Los Angeles Regional Water Quality Control Board

RESPONSE TO THE CITY OF GARDENA'S NOVEMBER 21, 2016 LETTER AND MODIFICATION TO THE BASELINE MONITORING DIRECTIVE TO THE CITY OF GARDENA PURSUANT TO THE MONITORING AND REPORTING PROGRAM IN ATTACHMENT E (LOS ANGELES COUNTY MUNICIPAL SEPARATE STORM SEWER SYSTEM (MS4) PERMIT - NPDES PERMIT NO. CAS004001; ORDER NO. R4-2012-0175)

Enclosure 1 - Los Angeles Water Board Response to November 21, 2016 Letter from the City of Gardena

Enclosure 2 – **Revised** Monitoring Requirements

Figure 1. City of Gardena Monitoring Stations

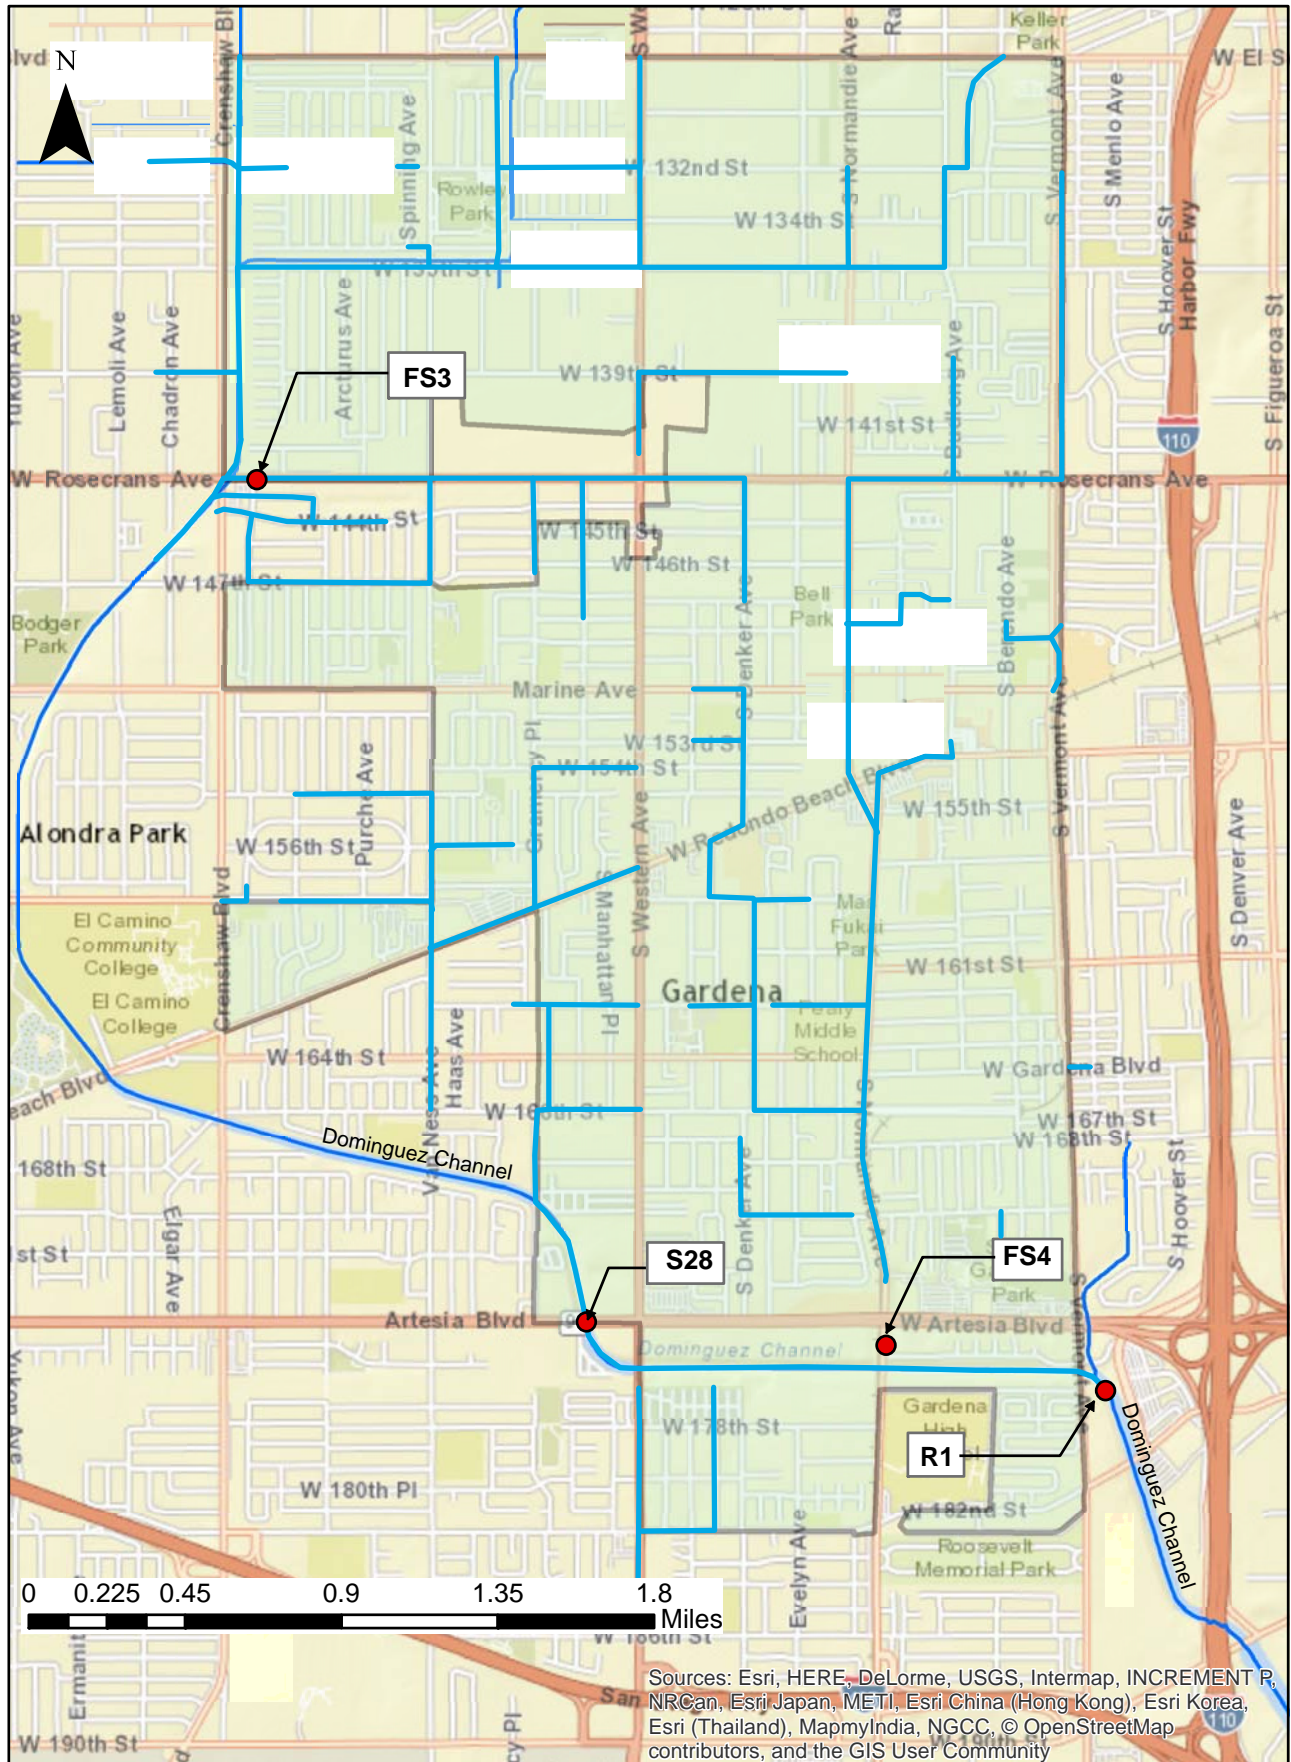
- As per the City's request, Mass Emission Station S28 shall be used as the City's receiving water monitoring station for the freshwater portion of Dominguez Channel.

- Monitoring location R1, located at the uppermost end of the Dominguez Channel Estuary, shall be used by the City only as a TMDL monitoring station for Dominguez Channel Estuary, where the City shall monitor sediment and fish tissue as per the Dominguez Channel and Greater Harbor Waters Toxic Pollutants TMDL (Harbor Toxics TMDL).

- Monitoring of pollutants in water and total suspended solids that is required to determine compliance with the Harbor Toxics TMDL shall be conducted at the designated outfall monitoring stations, i.e., ID # FS3 and FS4.
